NOV_SCE_EDC_ 20211207-01

NOTICE OF VIOLATION

Energy Safety Inspection Report

Report Name: SCE_EDC_20211207-01

Structure ID: 4941452

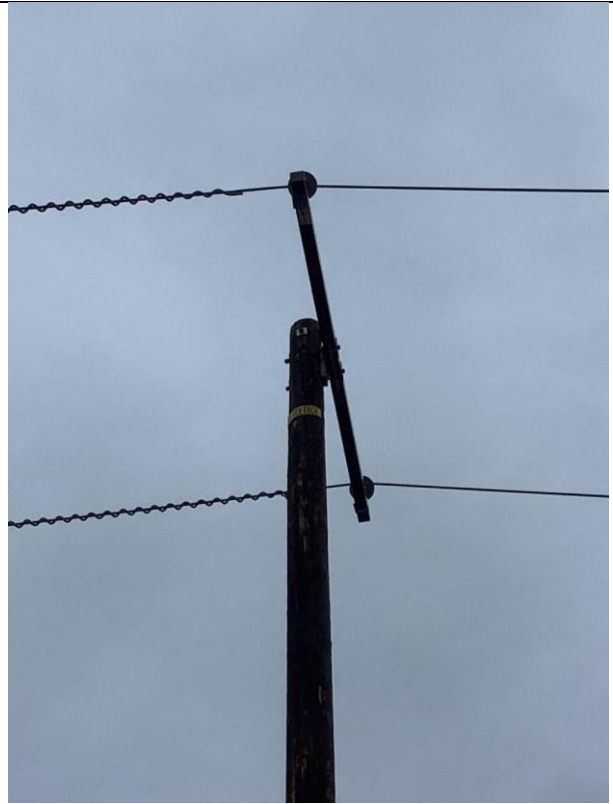
1. Violation 1: At poles numbered 4941453, 4941452, and 4941454 the pole identification tag did not match the identification number provided by SCE in its Quarterly Data Report (QDR). Energy Safety considers this data accuracy violation to be in the Minor risk category.
2. Violation 2: Per SCE's Distribution Overhead Construction (DOH), Section CC 150, page 3 of 5, covered conductor double dead-end construction, "if conductor is exposed, install bolted wedge connector cover." Also, DDS, Section 10, 5.7.C.1.f. states, "Covered conductor systems shall be an all-covered system." Per SCE's DOH, Section CC 150.4, page 5 of 5, "All overhead equipment shall utilize appropriate wildlife covers." Pole numbered 4415240E did not have bolted wedge connector cover installed at a double dead end

Line Item	Structure ID	HFTD	Initiative Number	Violation Type	Severity	Violation Description
1	4941453	Tier 2	7.3.3.3.1	Data Accuracy	Minor	Support structure ID provided by SCE is incorrect. Support structure provided by SCE is: 1289683E-MA. Structure ID on the pole is: 4941453
2	4941452	Tier 2	7.3.3.3.1	Data Accuracy	Minor	Support structure ID provided by SCE is incorrect. Support structure provided by SCE is: 1289684E. Structure ID on the pole is: 4941452
3	4941454E	Tier 3	7.3.3.3.1	Data Accuracy	Minor	Support structure ID provided by SCE is incorrect. Support structure provided by SCE is: 1289686E. Structure ID on the pole is: 4941454E
4	1289688E	Tier 3	7.3.3.3.1	Adherence to Protocol	Minor	Failure to install surge arrestor cover
5	4556900E	Tier 2	7.3.3.3.1	Completeness	Minor	Failure to install vibration dampers on a span
6	4554800	Tier 2	7.3.3.3.1	Adherence to Protocol	Minor	Failure to install vibration dampers on a span

Structure ID: 1289688E

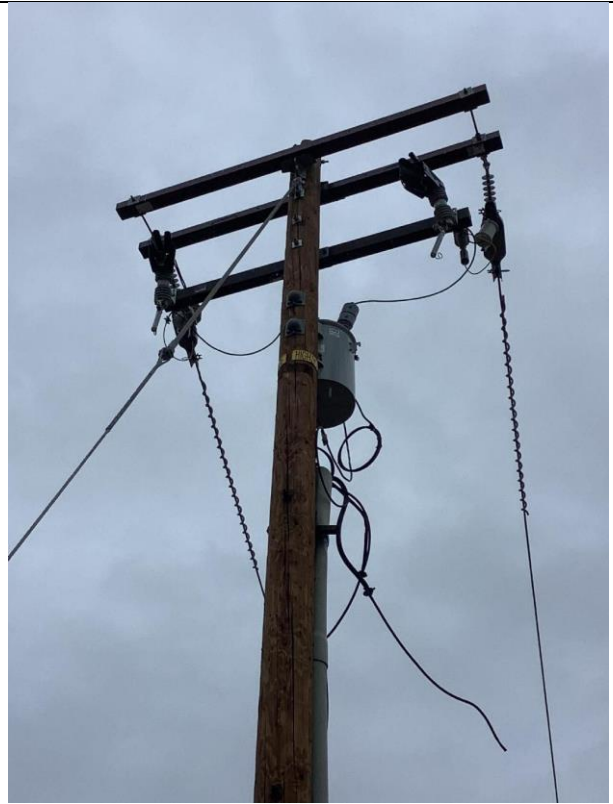
construction. Pole numbered 1289688E did not have a cover on the surge arrester clamp. Energy Safety considers this a violation for failure of adhering to protocol and in the Minor risk category.

Item4IA1Img1: Surge arrester clamp not covered

Item4IA2Img1: Close up of clamp not covered

Structure ID: 4556900E

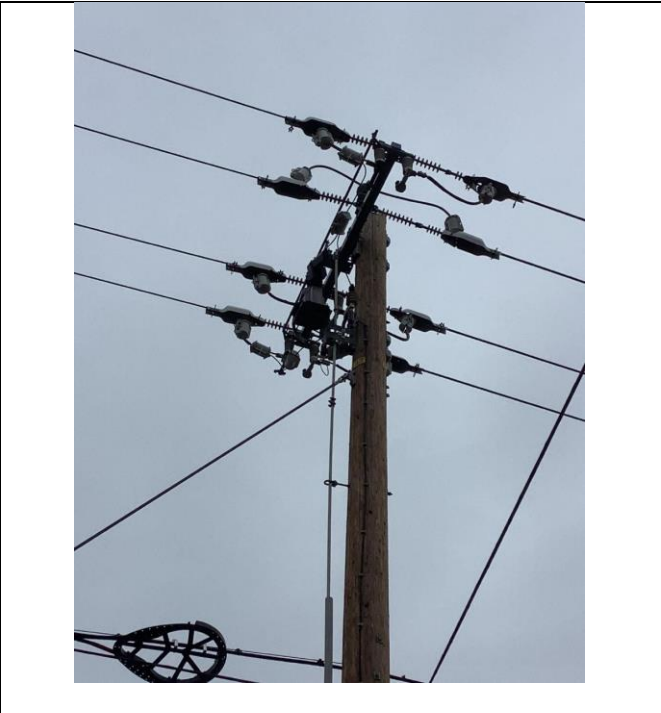
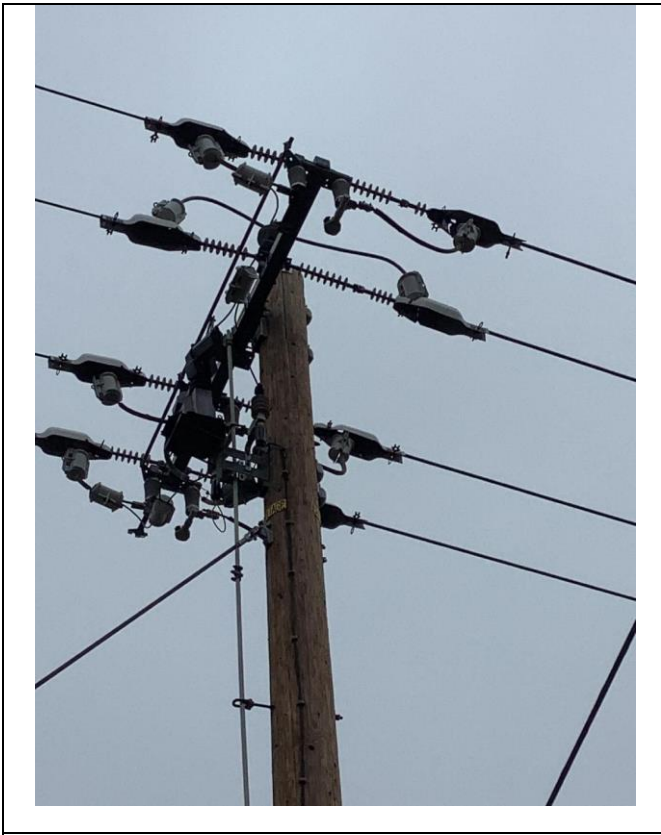
Item5IA1Img1: No vibration dampers installed

Structure ID: 4554800

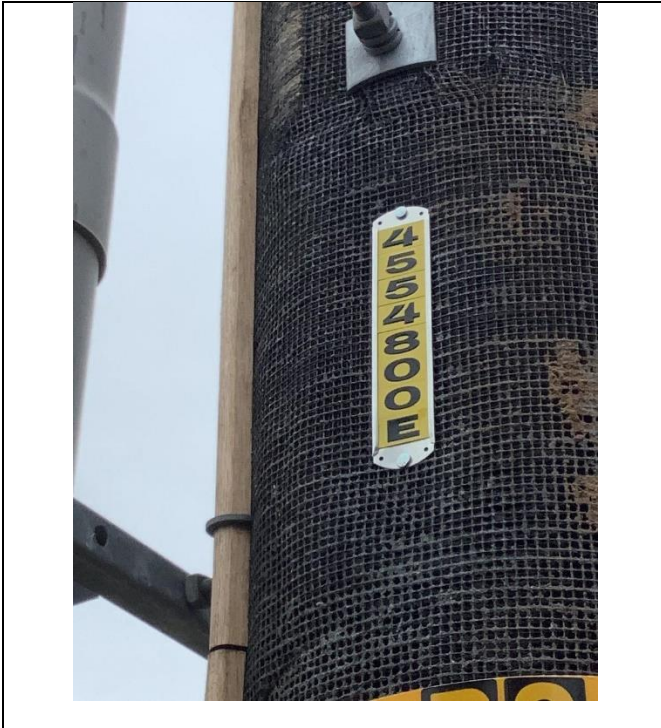
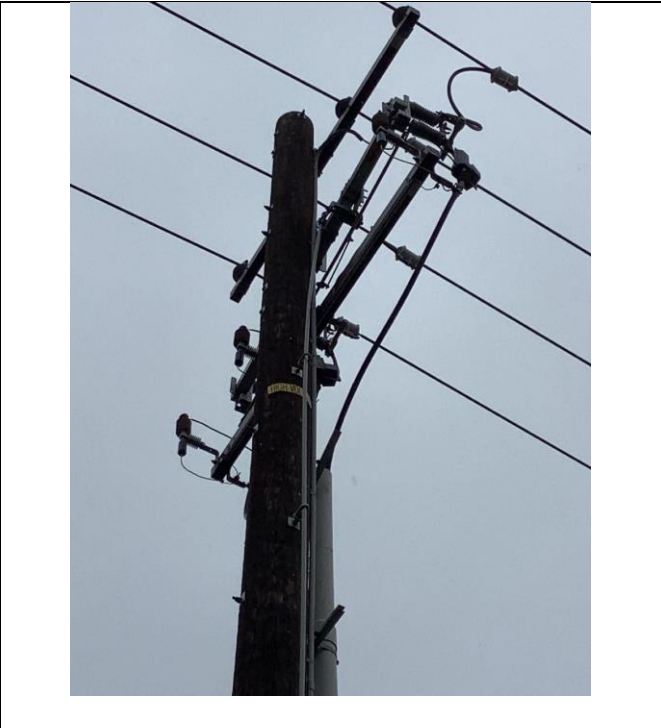
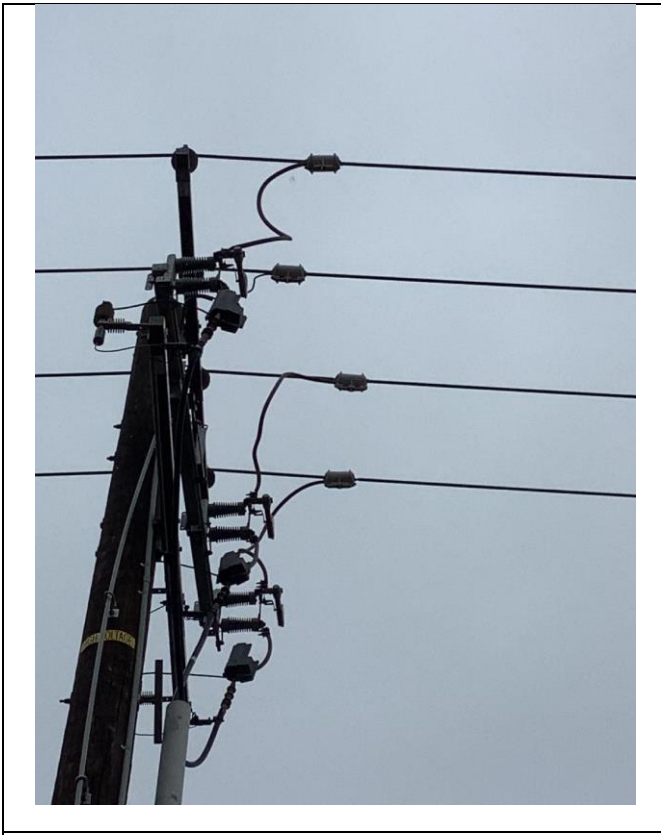
Item6IA1img1: No vibration dampers installed

Structure ID: 4554797E

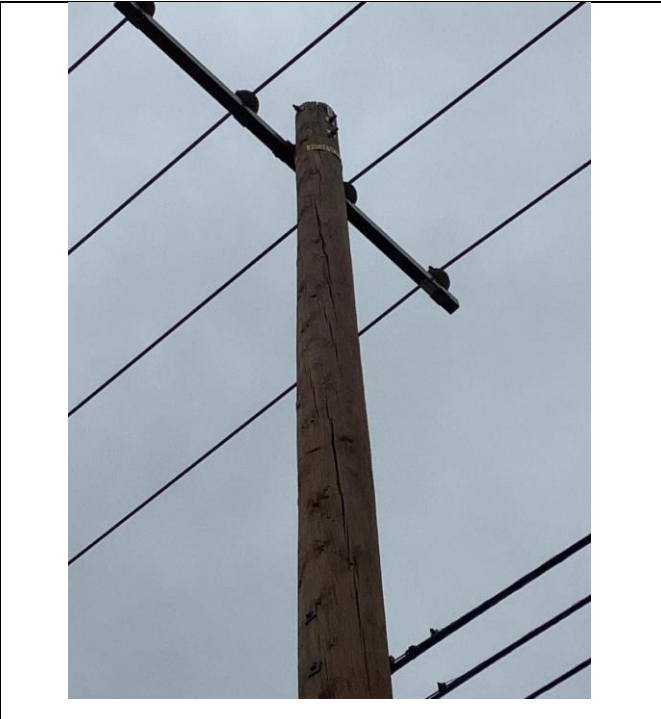
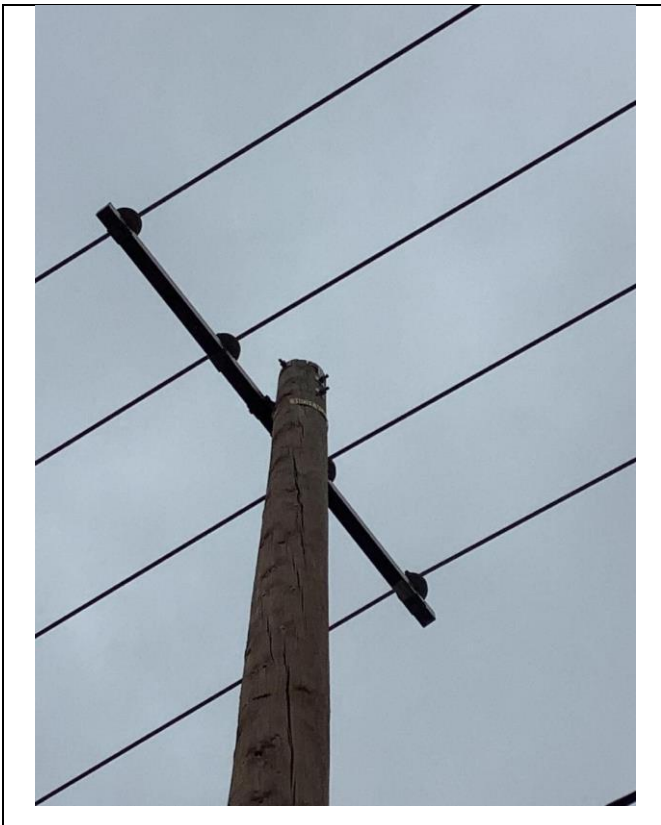
Item7IA1Img1: No vibration dampers installed

Structure ID: 4554795

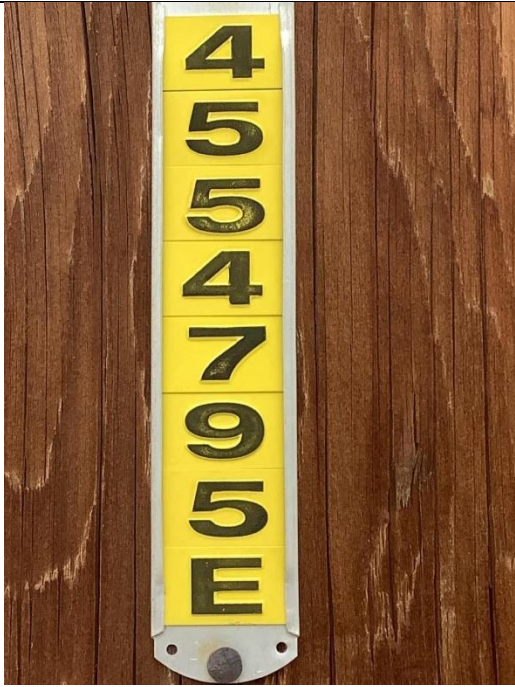
Item8IA1Img1: No vibration dampers installed

Structure ID: 4554792E

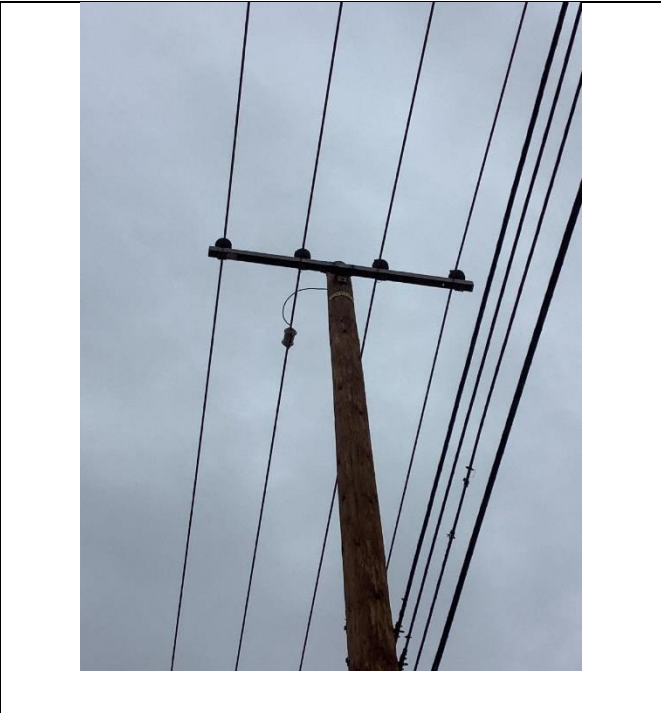
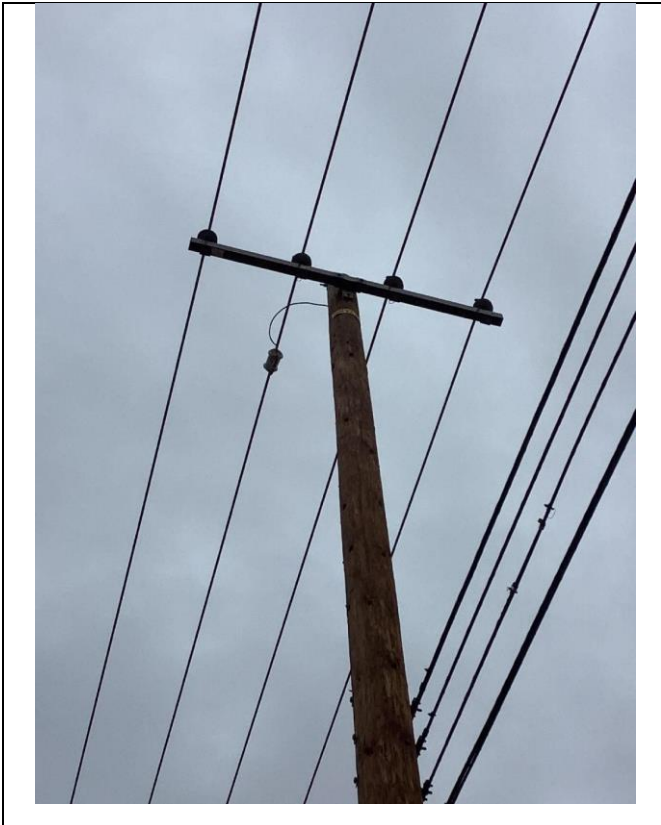
Item10IA1Img1: No vibration dampers installed

Structure ID: 276507E

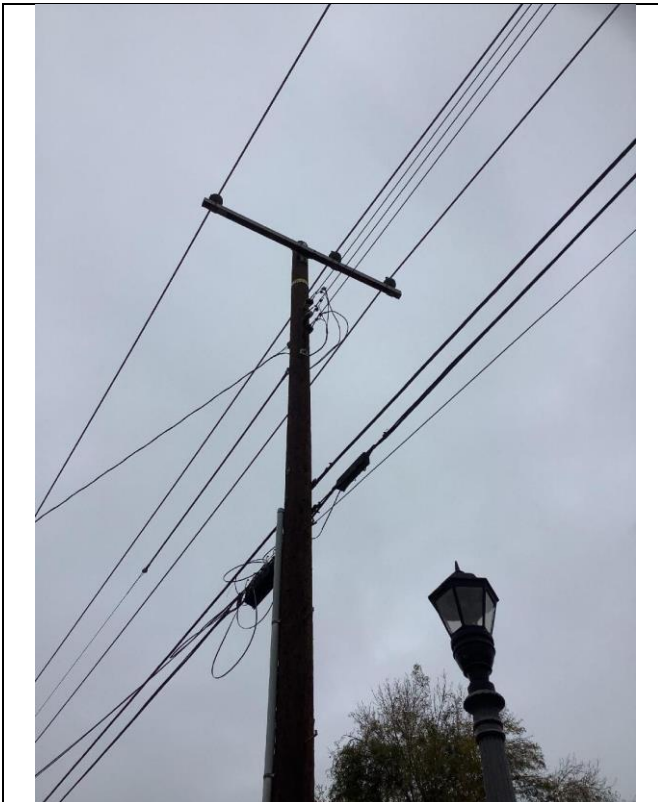
Item14IA1Img1: No vibration dampers installed

Structure ID: 4415240E

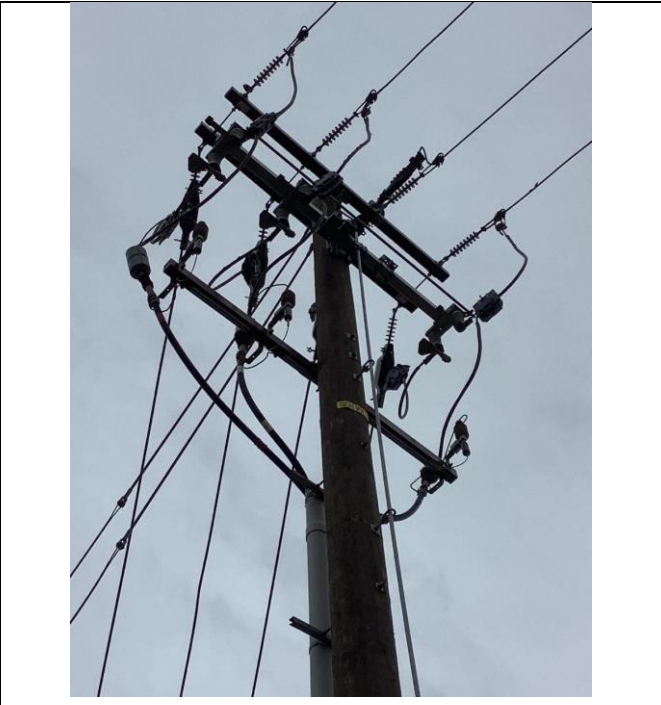
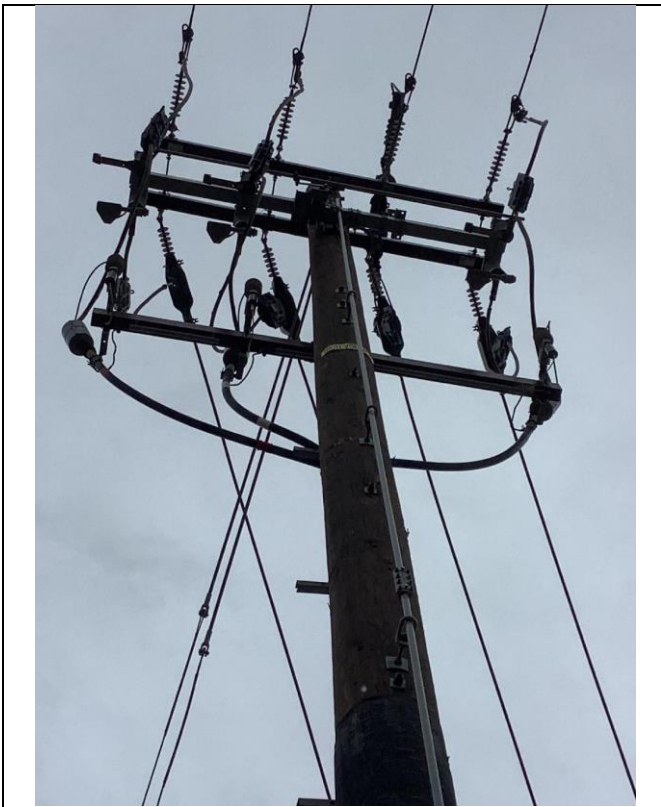
Item16IA1Img1: No vibration dampers installed

Item16IA2Img1: Bolted wedge connector cover not installed

Item16IA3Img1: No cover on jumper wire

Item16IA4Img1: Guy anchors left in in the ground

Structure ID: 4775179E

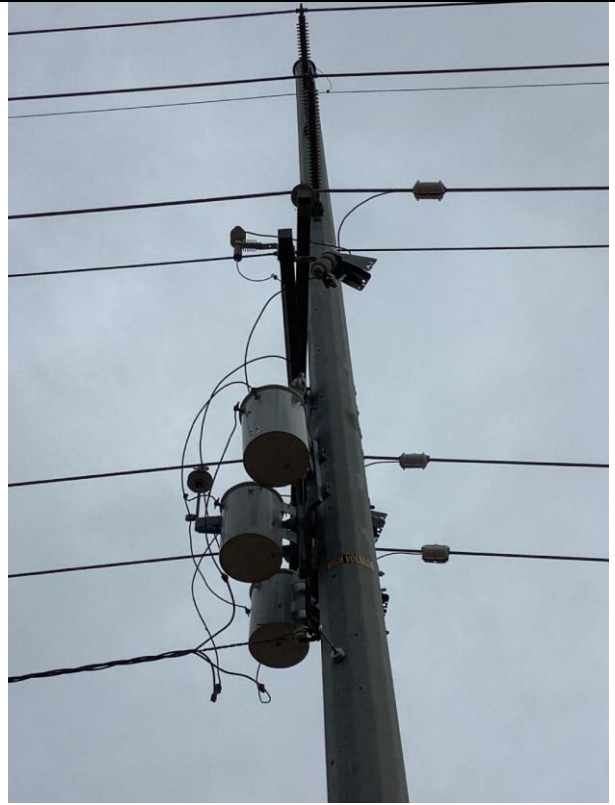
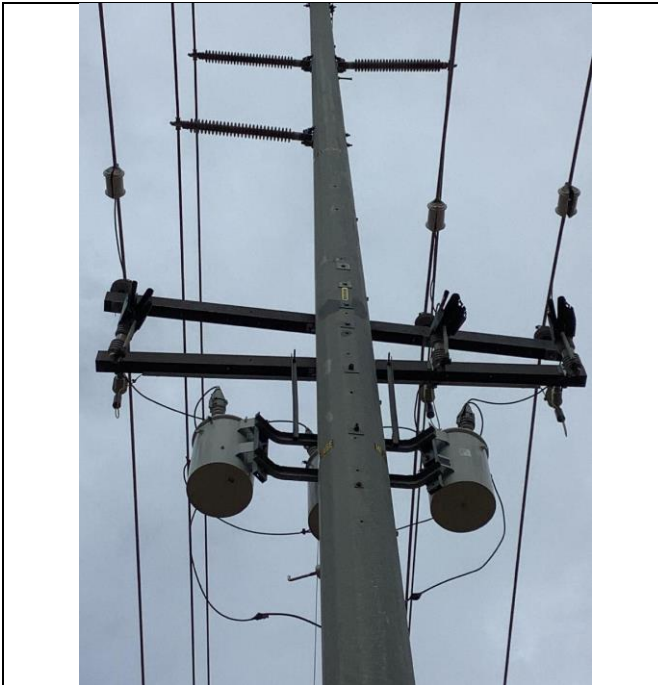
Item18IA1mg1: No vibration dampers installed
